S E R V I C E N O T E

**4263A LCR Meter**

**Modification to eliminate CPU hang up due to defective X'tal oscillators**

DATE: 19 February 1993

Figure 1.

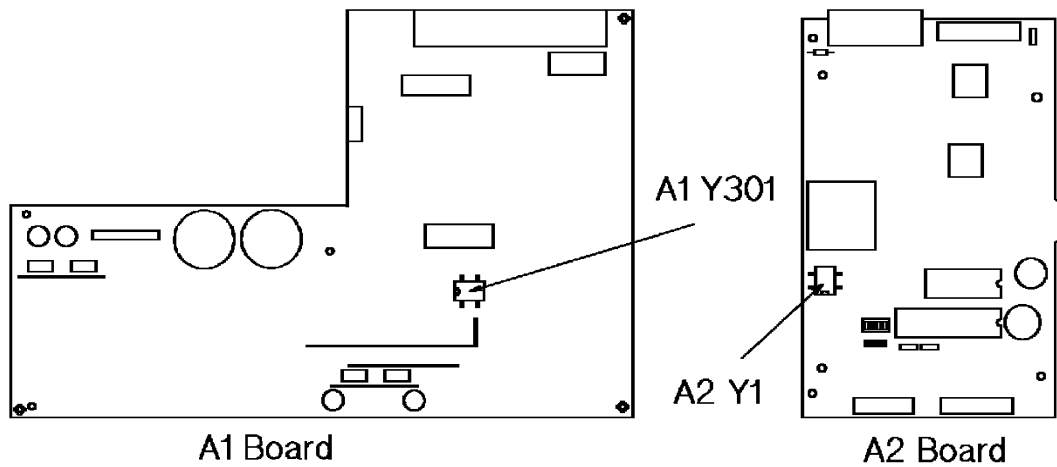
The 4263A units with serials given above may hang up intermittently. This is caused by the X'tal oscillator chip which has a problem in its manufacturing process. Two oscillator chips are used in the 4263A.

If the unit exhibits the symptom given above, try replacing the two X'tal oscillator chips with new ones. These components are SMD (Surface Mounted Devices) but don't require any special tools or techniques to replace them. Their pin pitch is wider than the general SMD.

Figure 1. shows the X'tal location.

Part No.	Qty.	Ref Designator	Description
1813-0773	1	A1 Y301	X'tal Oscillator, 20.48 MHz
1813-0708	1	A2 Y1	X'tal Oscillator, 16.0 MHz
